# Access Compliance Report

## Public Rights-of-Way

### (Curb Ramps)

Intersection ID: 24674	Main Street: CARMEL_RD	Cross Street: CARMEL_VISTA_LN	Location: SE
ADA ID: 41E130B3EDA4	Ramp Type: Perp	Initial Pass/Fail: Fail	Overall Compliance: No
		Severity Score: 10

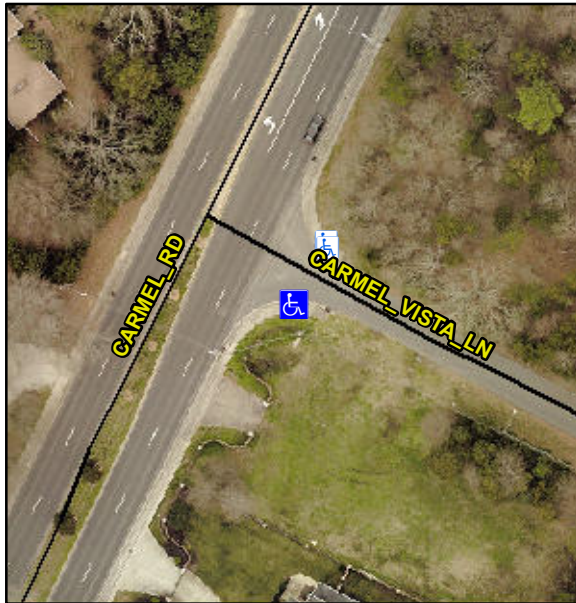
**Not Found, R304.5.1, R304.5.3**

Compliance	Description	Data	Compliance	Description	Data
N/A	Ramp Length (in)	57.0	Yes	Ramp Slope (%)	7.4
No	Ramp Width (in)	37.0	No	Ramp XSlope (%)	2.1
N/A	Flare Type LT	N/A	N/A	Flare Type RT	N/A
N/A	Flare Slope LT (%)	N/A	N/A	Flare Slope RT (%)	N/A
N/A	Flare Traversable LT?	N/A	N/A	Flare Traversable RT?	N/A
N/A	Landing Length (in)	N/A	N/A	DWS Provided?	N/A
N/A	Landing Width (in)	N/A	N/A	DWS Contrast?	N/A
N/A	Landing Slope (%)	N/A	N/A	DWS Length (in)	N/A
N/A	Landing X Slope (%)	N/A	N/A	DWS Full Width?	N/A
N/A	Landing Curb? (Y/N)	N/A	N/A	DWS Offset (in)	N/A
N/A	Shared Landing?	N/A			
N/A	Gutter Ponding?	N/A	N/A	Gutter Slope (%)	N/A
N/A	Gutter Lip Ht (in)	N/A	N/A	Gutter X Slope (%)	N/A
N/A	Painted X Walk1?	No	N/A	Painted X Walk2?	N/A
	X Walk 1 Direction	To NE		X Walk 2 Direction	N/A
N/A	X Walk 1 Width (in)	N/A	N/A	X Walk 2 Width (in)	N/A
	X Walk 1 Slope (%)	1.6		X Walk 2 Slope (%)	N/A
	X Walk 1 X Slope (%)	1.4		X Walk 2 X Slope (%)	N/A

**Remove & Replace Entire Ramp.**
